**Government of India  
Ministry of Railways  
Research, Designs & Standard Organisation  
Manak Nagar, Lucknow-226011**

**Modification Sheet No. ELRS/MS/0262**

**1.0 Title :** Improvement measures to improve the reliability of air dryers.

Arrangement of auto drain valve as per enclosed Annexure-I.

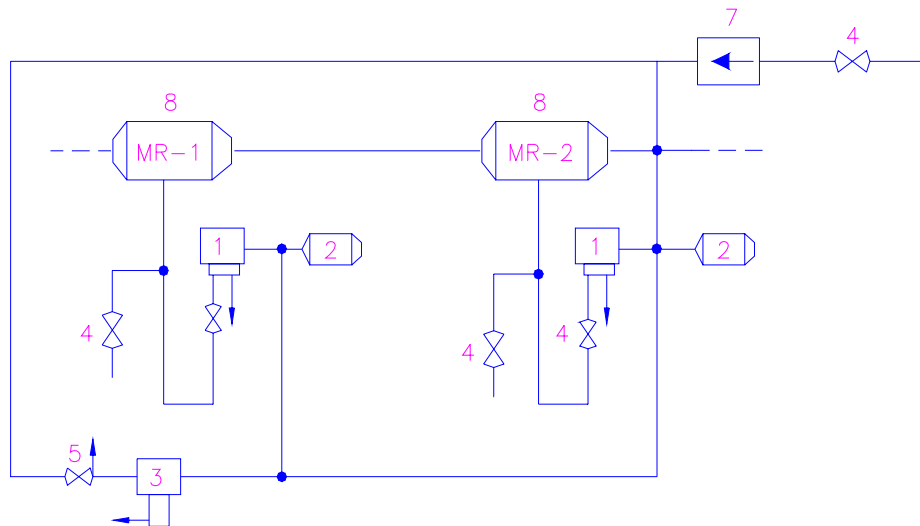
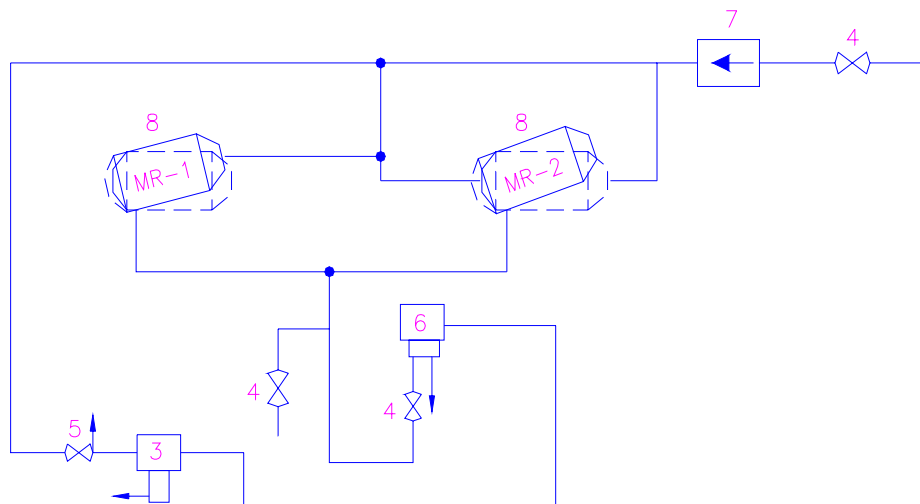
- (a) The control supply going from RGCP to 'VEAD' valve should be disconnected.
- (b) The 'VEAD' valve should be given the control supply through the timer set at '2 minutes' provided in the air dryer control card. This will also require laying of a new control cable.

(iv) Only one 'D1' type auto drain valve of original WABCO design should be used in place of two auto drain valves of 'Salem' design which are presently provided as per enclosed pipe line layout.

1. AUTO DRAIN VALVE OF SALEM TYPE.
2. TIMING CHAMBER FOR AUTO DRAIN VALVE.
3. VEAD VALVE TO BE ACTIVATED BY RGCP.
4. 1/2" DRAIN COCK.
5. 3/8" CDC WITH VENT.
6. AUTO DRAIN VALVE 'D.1' TYPE TO BE ACTIVATED BY TIMER PROVIDED IN CONTROL. CARD OF AIR DRER.
7. 3/8" AIR STRAINER
8. MAIN RESERVOIR

TILING ARRANGMENT OF MR 1 & MR 2 IN MODIFIED ARRANGEMENT TO BE FOLLOWED BY WORKSHOPS DURING POH AND CLW IN NEWLY MANUFACTURED LOCOMOTIVES.
